2	STAFF SUMMA	AR'	Y SHEET			
	ТО	ACTION	SIGNATURE (Surname),	GRADE AND DATE		ТО	ACTION	SIGNATUR	E (Surname), GRADE AND DATE
1	USAFA/ JA	Coord C	2 DET 2	007	5				
2	10 MSG/ CD	Coord	4000 2	2007	7			Gre	9,
3	10 MSG/ CC	Coord	70 40 CT 20	8	3		7	38 MC	el Mis Stray
4	HQ 10 ABW/CV	Coord	Rush Col		9			the	had a FONSE
5	HQ 10 ABW/CC	Sig	100-1	100 11 oct of	8			please	was not year,
SU	IRNAME OF AC	TION OFFICER	AND GRADE S	/MBOL	F	PHONE		TYPIST'S INITIALS	SUSPENSE DATE UD appropria
M	r. Normandi	e, Cont	1	CES/CEV	3	333-3233		vld	Processec.
	BJECT	Significant I	mpact (FONSI) for the	Golf Learning Cer	nter	and Driving	g Range		SEP 2 4 2007

FINDING OF NO SIGNIFICANT IMPACT CONSTRUCT GOLF LEARNING CENTER AND DRIVING RANGE UNITED STATES AIR FORCE ACADEMY, CO

Golf Learning Center and Driving Range

Headquarters 10th Air Base Wing, United States Air Force Academy, CO

FIGURE 1-3; LOCATION OF EISENHOWER GOLF COURSE

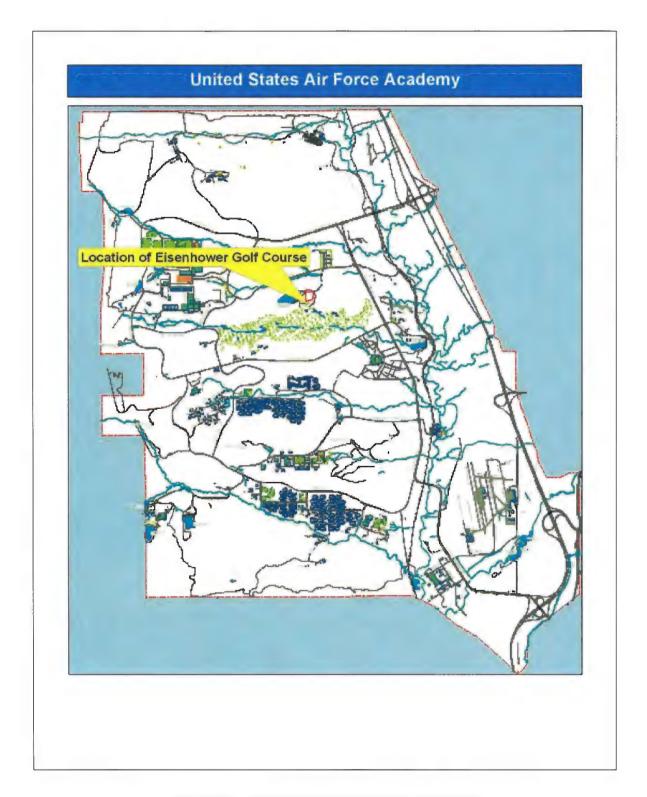
- (3) Paragraph 1.3 is borrowed from the West Perimeter Protection Plan and cites to that plan vice the one intended.
- (4) A common theme throughout the precise location of this action is not well documented noting that we are really dealing with two different but interrelated projects the building and the driving range. For example, as the diagram at figure 1-3 notes (and as my own observations confirm) it appears that a portion of the driving range itself (and perhaps even more so the safety fan which is always more to the right than the left because most right handed players tend to slice the ball) overlaps the entry road to the golf course (not a very good situation). Also note that figure 2-1 shows a different boundary that figure 1-3.
